## July 23, 2024

Re: Response Letter, Natural Resource Inventory/Forest Stand Delineation (NRI/FSD) #420240850 - Persimmon Tree Subdivision

Figure 3. 3D Model: Stream Morphology Analysis, Cross section

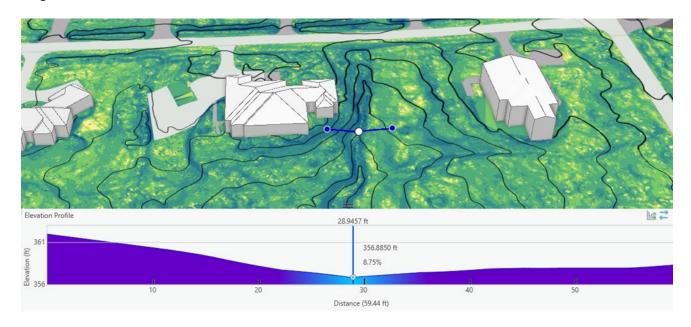
Additionally, Planning staff created a <u>3D model</u> using LIDAR data and a contour layer to demonstrate the presence of a well-developed channel with clear sinuosity, continuous bed, and bank throughout the natural channel's length, excluding the concrete channel between

9805 Logan Drive and 9901 Logan Drive. The model and the video previously provided by the applicant, clearly show sinuous patterns in the terrain. The video also shows flow during a heavy rain event. During site visits on November 14, 2023 and April 25, 2024, Planning staff found evidence of stream flow. Additionally, the 3D model also depicts evidence that stream banks were up to 2 feet high. Soil and core samples were collected during the site visits for groundwater testing, and observations included decayed leaf matter, sorted sediments, streambed forms, frequent flow marks, algae cover, and wetland vegetation. Evidence of erosion in the form of exposed vegetation roots along the banks, sediment, and debris was observed at 9306 Persimmon Tree Rd and the outfall of the pipes during Planning staff visits. Wetland vegetation such as American Sycamore and algae-covered rocks were identified along the stream channel. Groundwater was also noted during the Department of Permitting Services (DPS) inspection (pictures provided by DPS on December 2, 2023), and various hydrologic conditions, such as the presence of muck and accumulation of organic matter within a few inches of the topsoil on the stream banks were also observed.

The evidence above indicates that the channel was well-developed and exhibited the characteristic sinuosity of intermittent and perennial streams.
